VOLUME 11 ISSUE 11 MARCH 1975

# UNIVERSAL PUSH BUTTON MODULE REPLACEMENT 02-39096-3 = (PART NUMBER 02-39096-103)

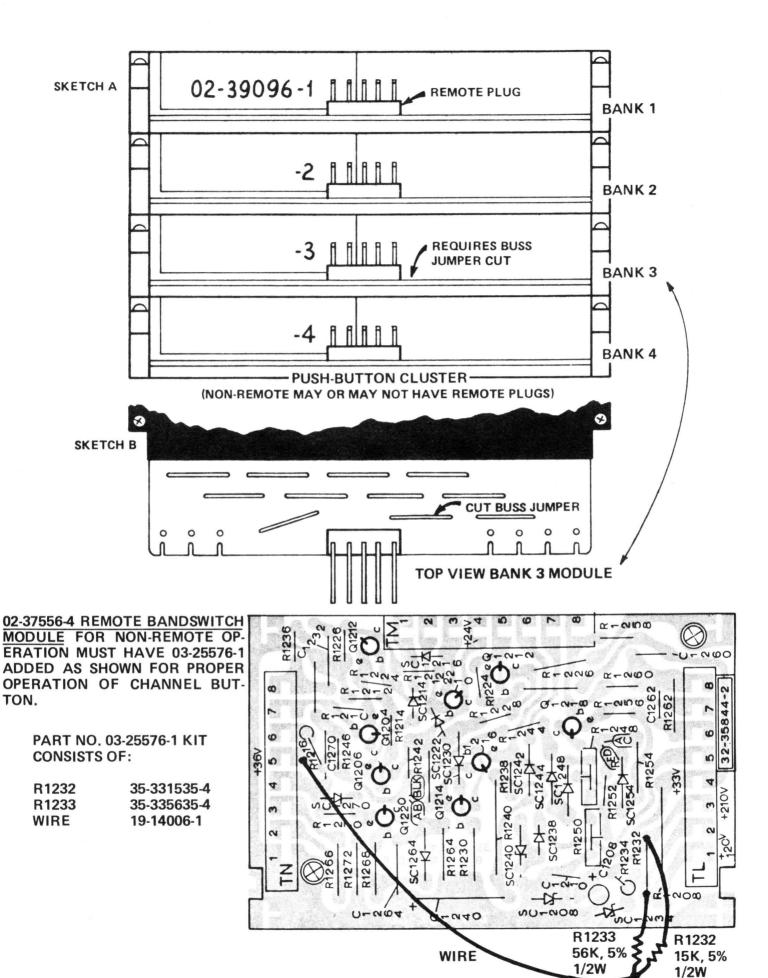
- 1.) This unit will replace remote and non-remote modules in the Push Button Cluster.
- 2.) This unit has a male remote plug which is used for remote units and ignored for non-remote modules.

- 1.) The original module may have a dash one (-1), two (-2), three (-3) or four (-4) after the part number. The modules, except for bank three (3), shown on Sketch A, are alike and need no modification for replacement.
- 2.) The third bank or position three, shown on Sketch A, is the split bank for UHF-VHF. When replacing bank 3 module, with the enclosed replacement, it is necessary to open the buss jumper lead location shown on Sketch B. This buss jumper is located directly to the upper right corner of the remote plug on the module. Use cutter pliers to open both ends on top of the board.

Merely cutting the buss line does not automatically convert that bank to a split UHF-VHF mode, unless the wiring in that cluster has been modified for such operation. Bank number 3 is the only bank factory wired for such operation. It may be possible in some UHF areas that additional bank modifications were made to the cluster in the field. In this case, always check the buss jumper on the bank other than 3, if the jumper has been cut. As a double check, see if UHF callouts are on the button. If so, the jumper should be cut on the replacement unit to match the original unit.
